Field Bulletin

V3 GP Gate Issue

Ref: UKE022

Inability to power and test V3 (Razr) on Wingate.

Fig 1.

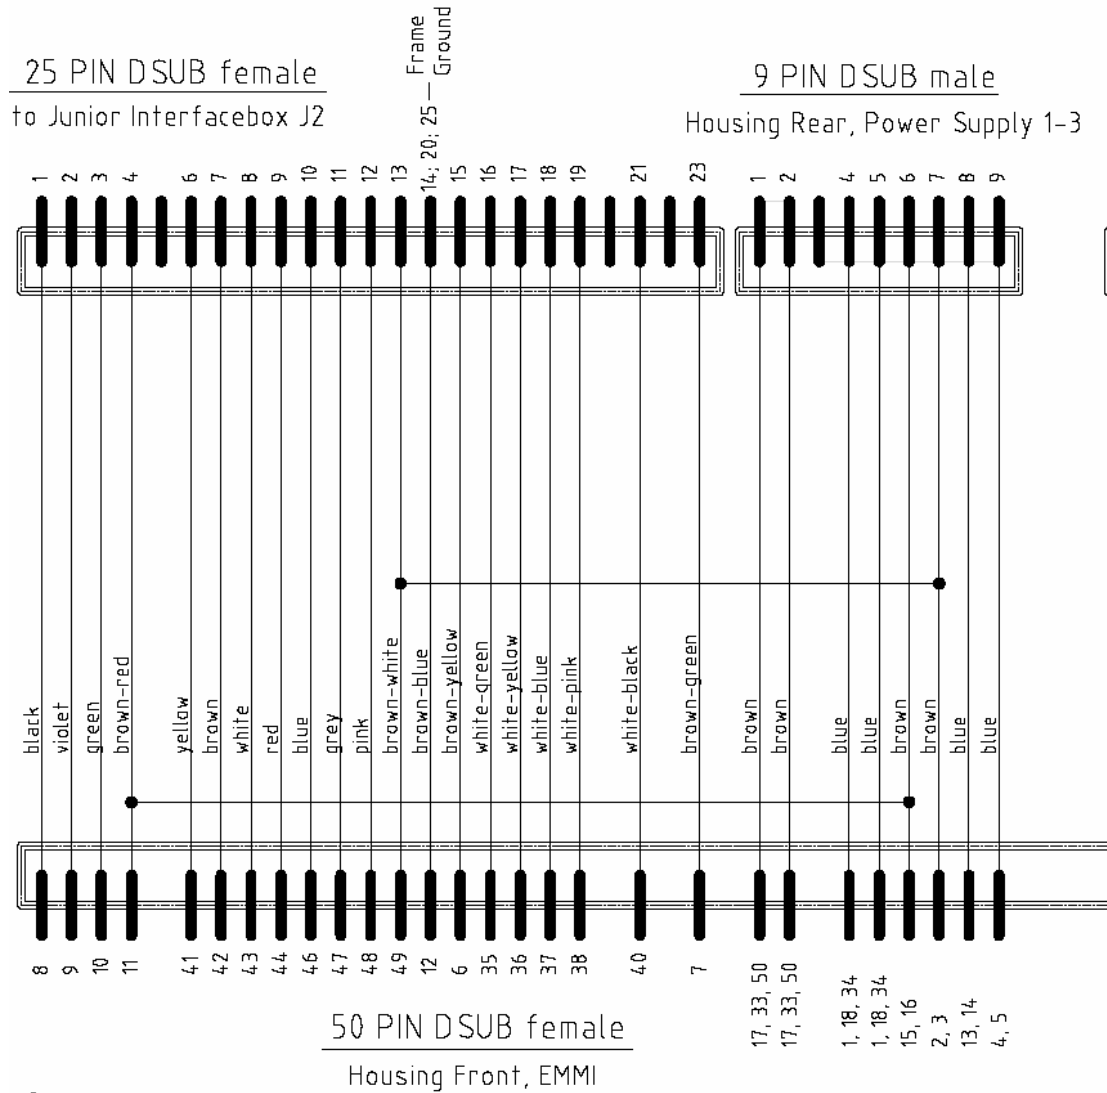
Check Pins 11 and 15/16 are short.

Check Pins 49 and 2/3 are short.

If these are found to be open circuit then carry out the following modification:

Open the EMMI / Junior Box Casing and identify the connections detailed in Fig1. Make the shorts between the pins and re-assemble the box. You should now be able to interface to V3 Phones by using GPGate.
